ADDENDUM No. 1

RFP No. 25-10

WESTGATE WATER MAIN PROJECT

S MAPLE RECONNECTIONS AND ZINGERMANS WATER LEAD

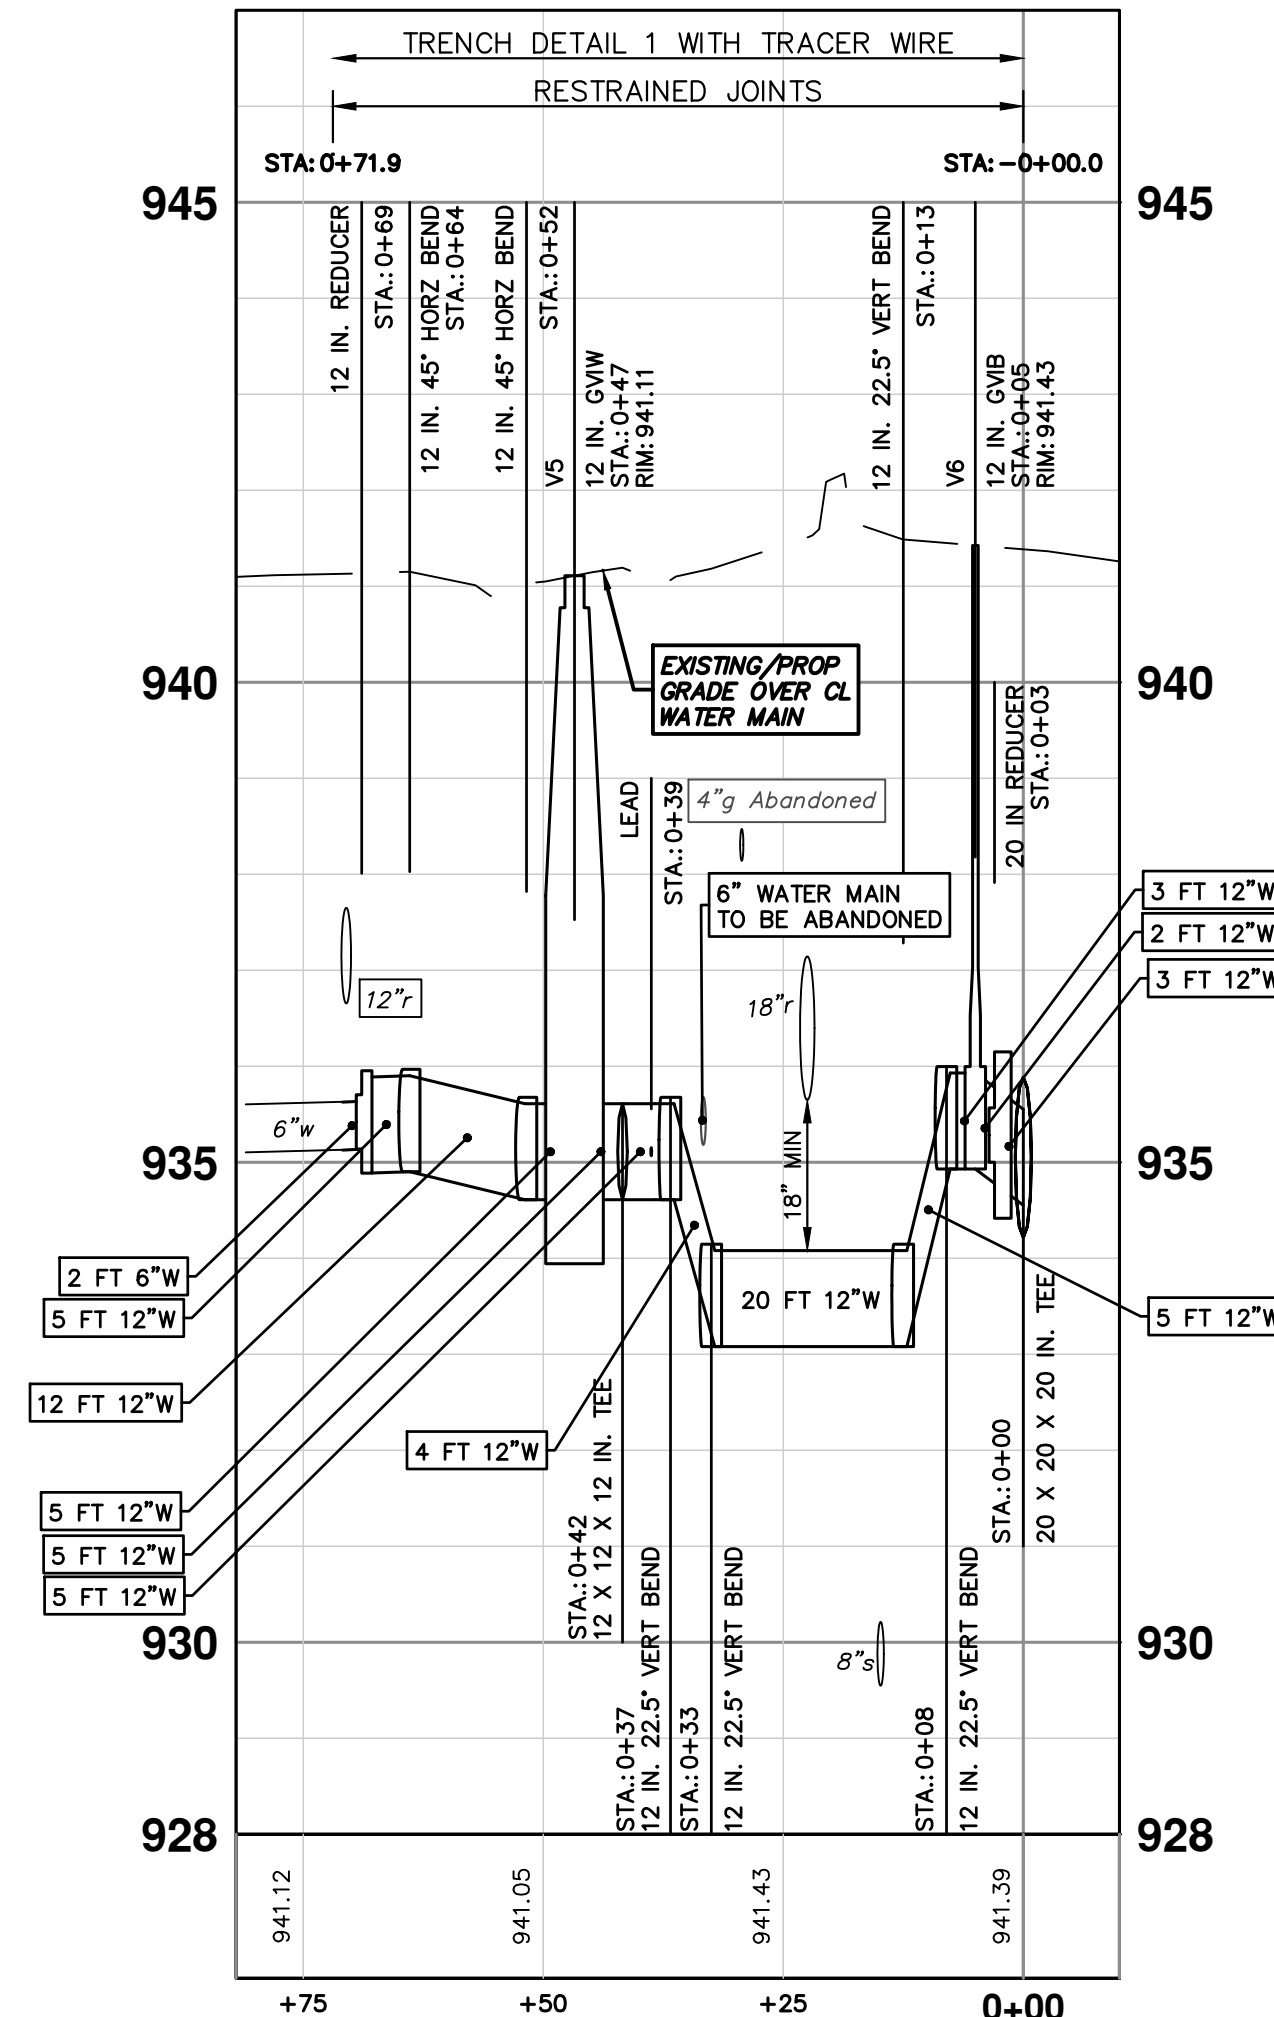
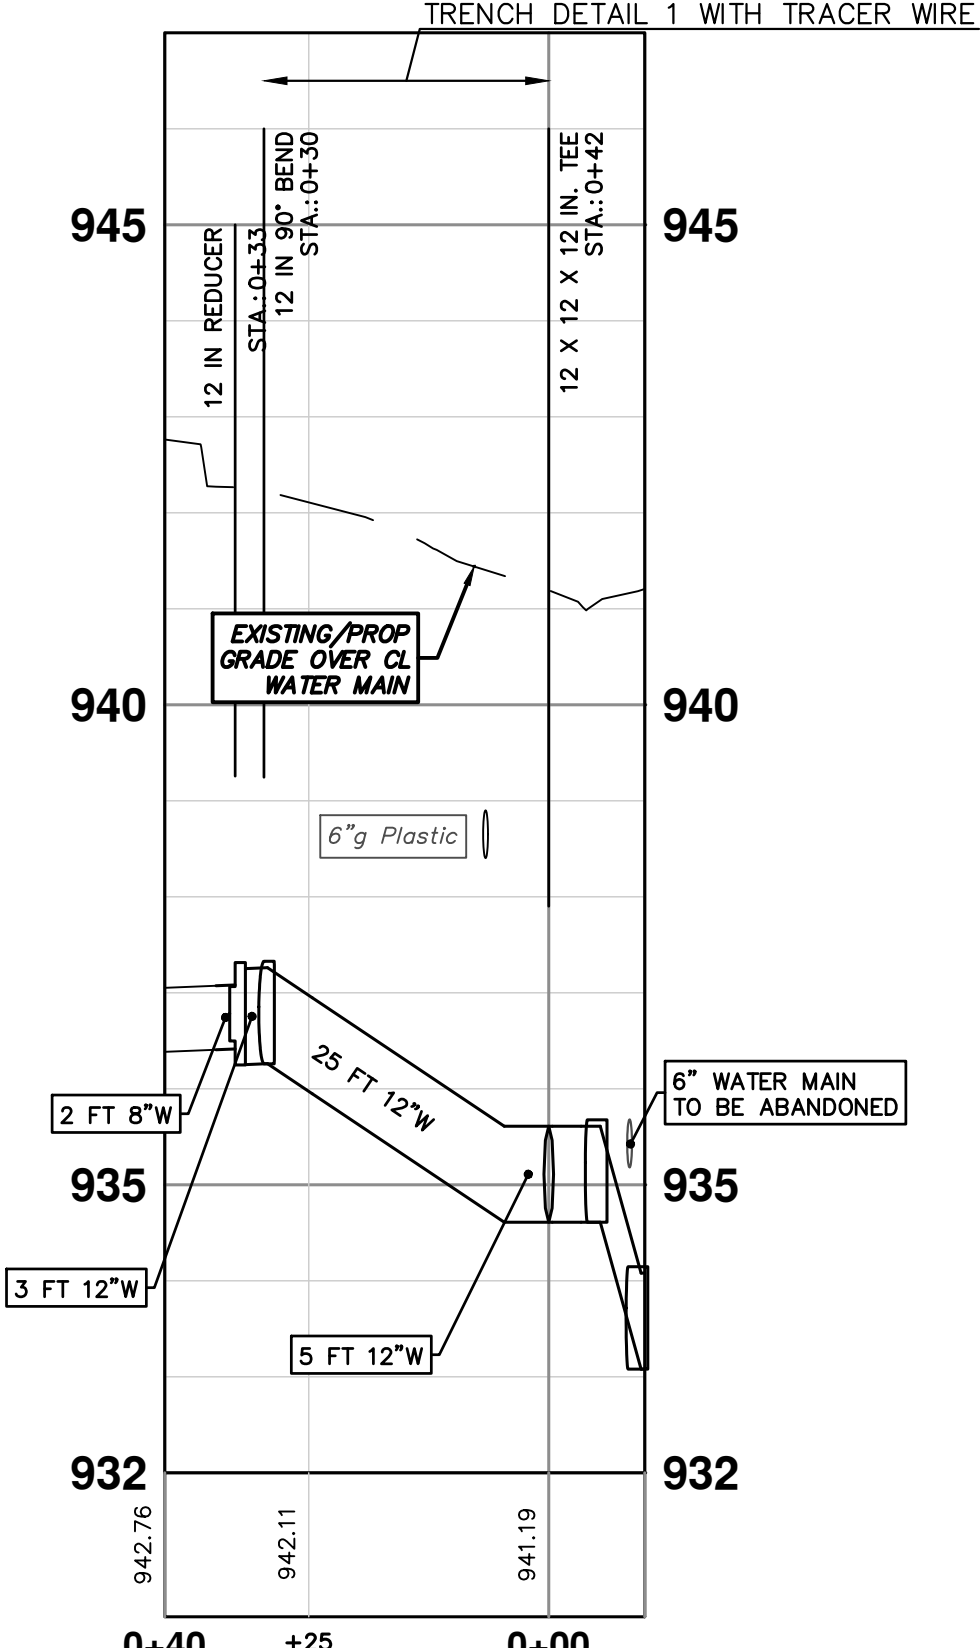
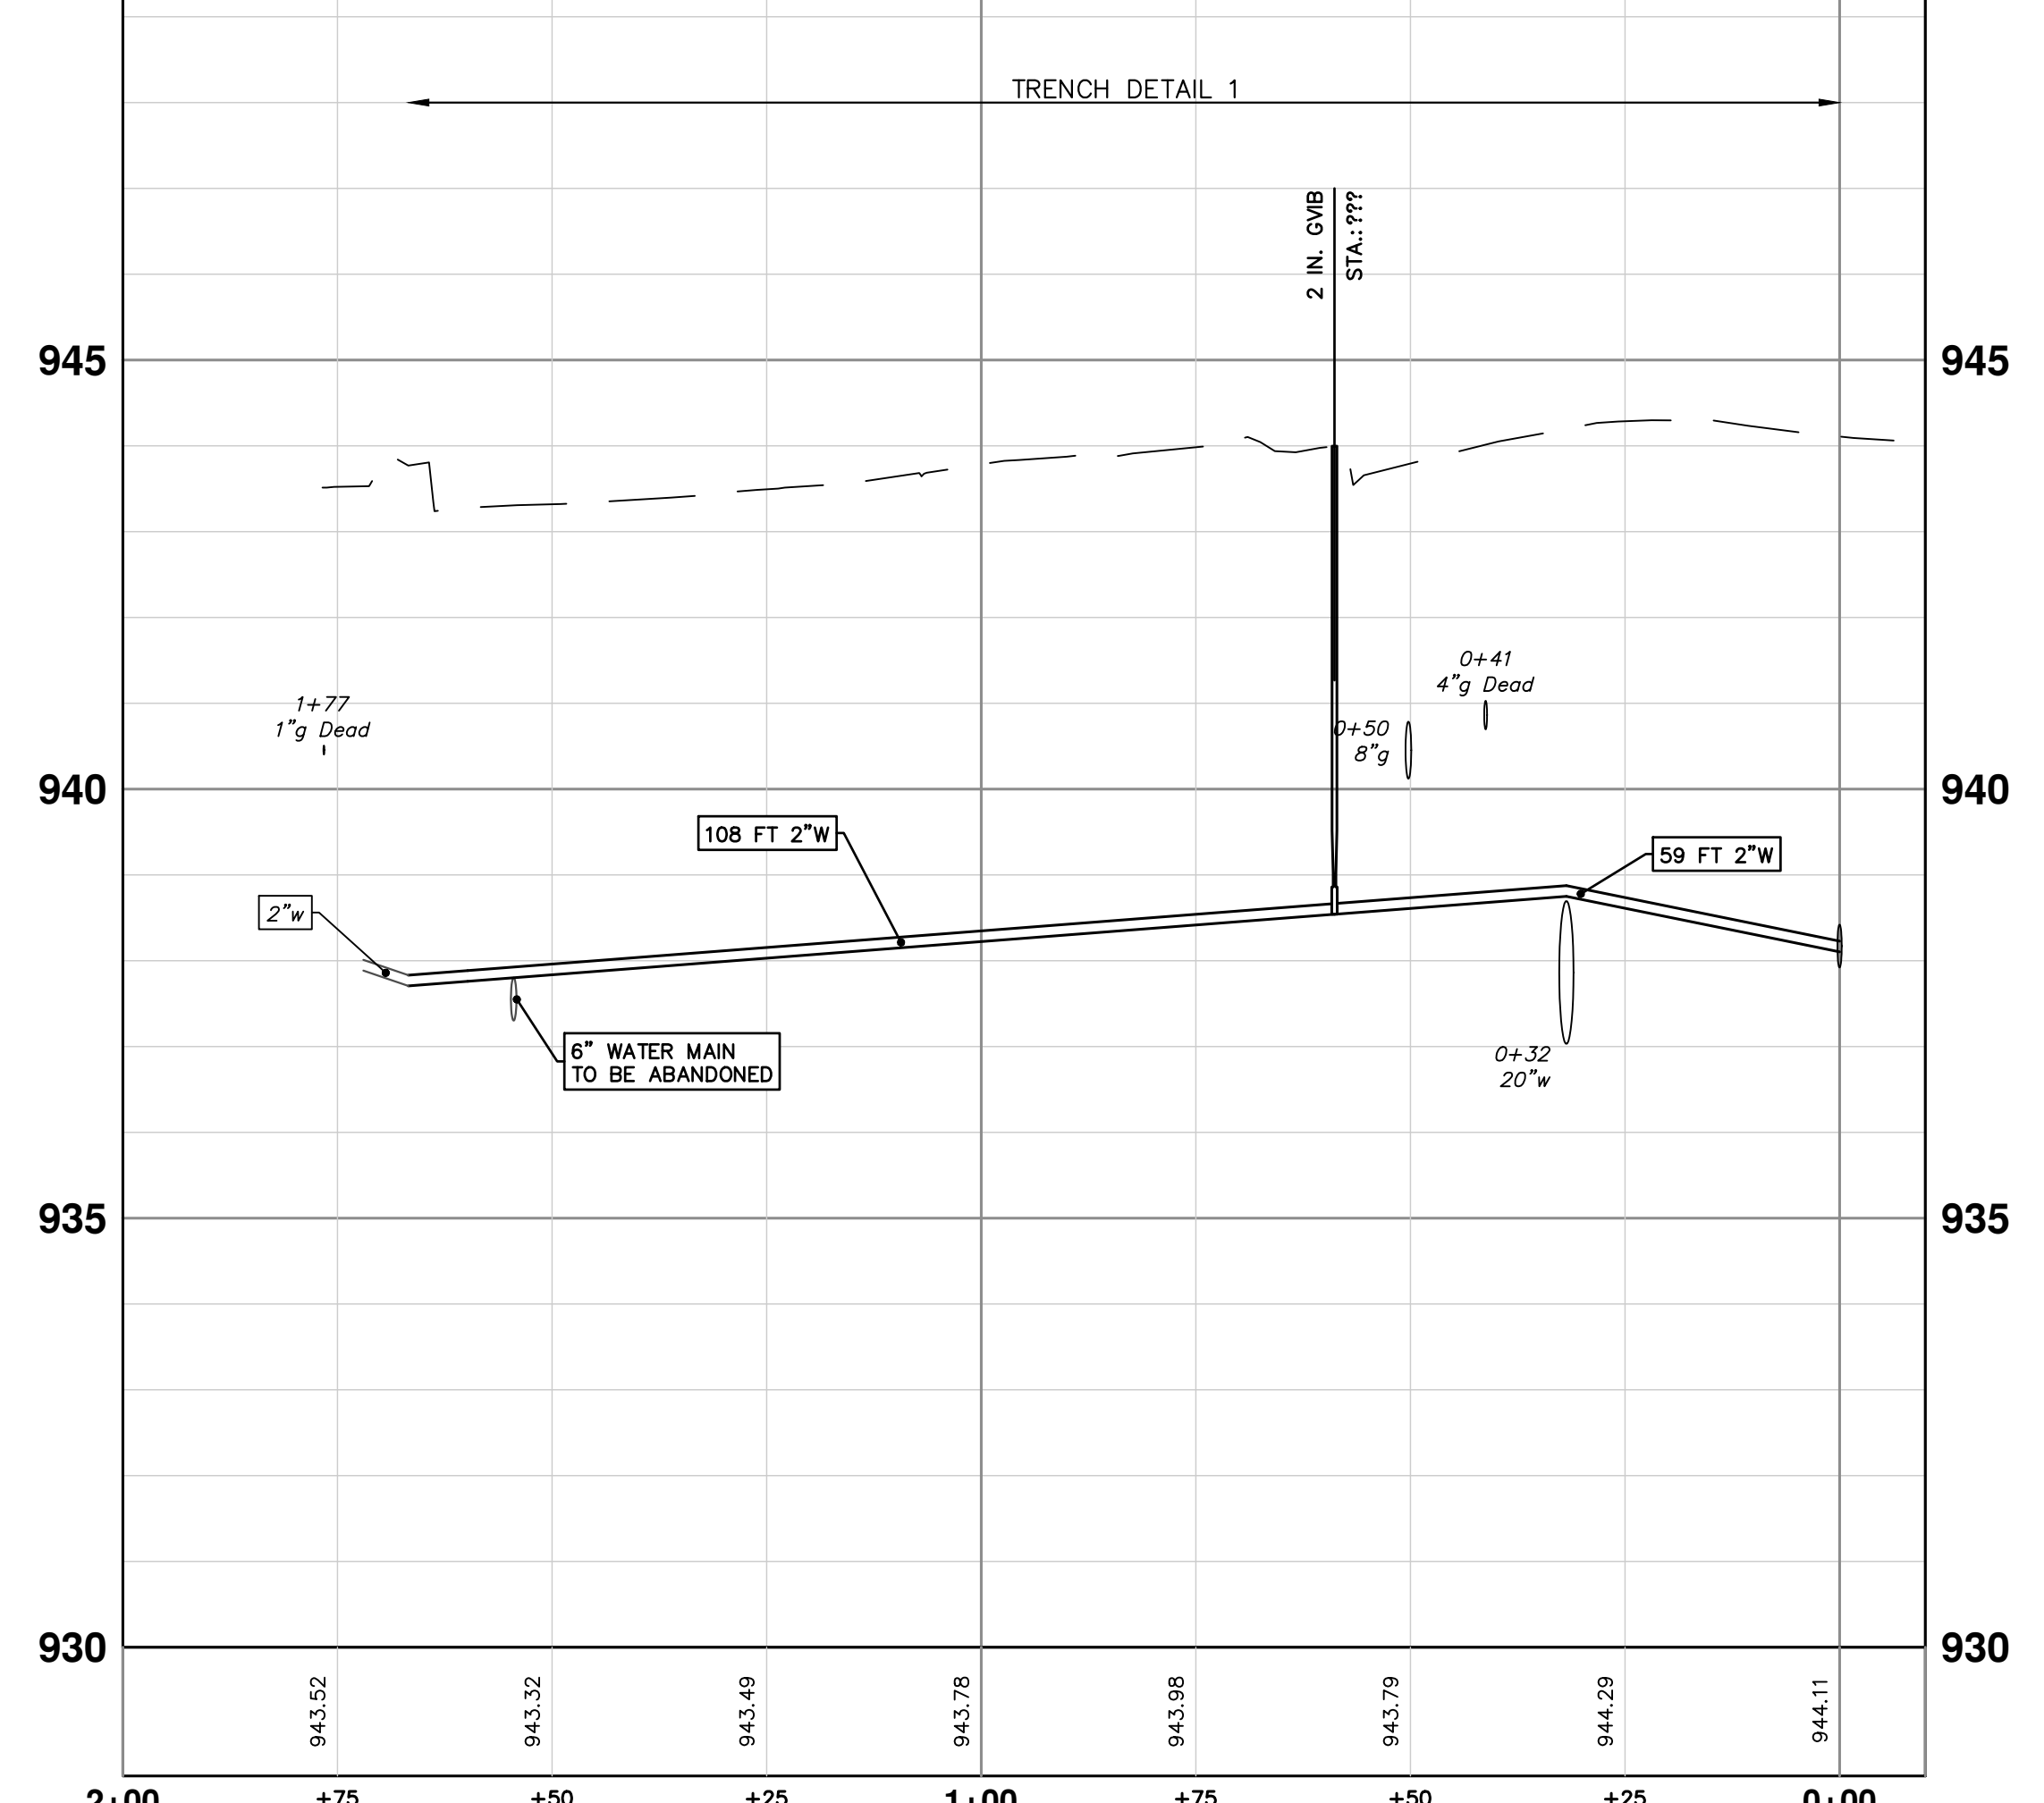
Question 51: What is the testing procedure for the South Maple Road / Lewis Jewelers Hydrant reconnection. This work is referenced as a "tie-in" in the plans. Does this mean pipe is to be swabbed and directly tied in or will the entire portion of this work need to follow the standard pressure testing and chlorination procedure. Please confirm a 4-week detour of this area will be acceptable if standard testing procedures are required.

Question 52: There is proposed water line work shown at the S Maple Road / Lewis Jewelers Tie-in. The plan view does not have any callouts for work and a profile is not provided. Please clarify what this is.

Answer 51: This tie-in section is to be tested at the same time for the segment that is ready to be tested on plans. Anything more than 20 ft length of water main pipe needs to be tested. Deviations to this plan that still met the standard testing procedures can be approved by Project Manager.
